Access Compliance Report Public Rights-of-Way (Curb Ramps)

Main Street: MAIN_ST Cross Street: SIENNA_PKWY Location: NE

ADA ID: RPRK211022123442 Ramp Type: Type 4 - Parallel Initial Pass/Fail: Fail Overall Compliance: No Severity Score: 15

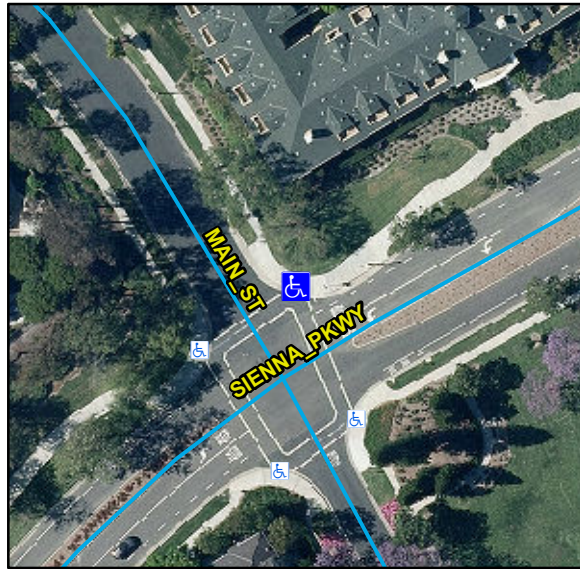
Compliance	Description	Data	Compliance	Description	Data
N/A	Ramp Length LT (in)	115	N/A	Ramp Length RT (in)	110
Yes	Ramp Width LT (in)	90	Yes	Ramp Width RT (in)	90
Yes	Ramp Run Slope LT (%)	3.4	Yes	Ramp Run Slope RT (%)	4
No	Ramp Cross Slope LT (%)	7	No	Ramp Cross Slope RT (%)	2.3
N/A	Landing Present	N/A	N/A	DWS Provided	N/A
N/A	Landing Length (in)	N/A	N/A	DWS Contrast	N/A
N/A	Landing Width (in)	N/A	N/A	DWS Length (in)	N/A
N/A	Landing Run Slope (%)	N/A	N/A	DWS Full Width	N/A
N/A	Landing Cross Slope (%)	N/A		DWS Offset Type	N/A
N/A	Landing Movement Obstructed?	N/A	N/A	DWS Offset Left (in)	N/A
	Landing Movement Type	N/A	N/A	DWS Offset Right (in)	N/A
N/A	Landing Shared	N/A			
N/A	Clear Space	Yes			
N/A	Clear Space To Crosswalk (in)	48			
N/A	Marked Crosswalk 1	Yes	N/A	Marked Crosswalk 2	Yes
	Crossing 1 Direction	W		Crossing 2 Direction	S
	Marked Crosswalk 1 Width (in)	90		Marked Crosswalk 2 Width (in)	90
N/A	Ramp Inside Crosswalk 1	Yes	N/A	Ramp Inside Crosswalk 2	Yes

Crossing 1 Slope (%)	6.9		Crossing 2 Slope (%)	5
	Crossing 1 Cross Slope (%)	1.9		Crossing 2 Cross Slope (%)	1.4
N/A	Gutter Ponding	N/A	No	Curb Slope	11.3
Yes	Gutter Lip Height (in)	0		Road Run Slope (%)	0.4
N/A	Gutter Run Slope (%)	N/A		Road Cross Slope (%)	6.1
N/A	Gutter Cross Slope (%)	N/A	No	Perpendicular Joint Present	No
Yes	Overall Surface Condition	Acceptable			
	Cross Gutter Present?	No		Spandrel Present?	No
	Replace Cross Gutter?	N/A		Replace Spandrel?	N/A

Remove & Replace Curb Ramp With Two New Directional Ramps or Equivalent.
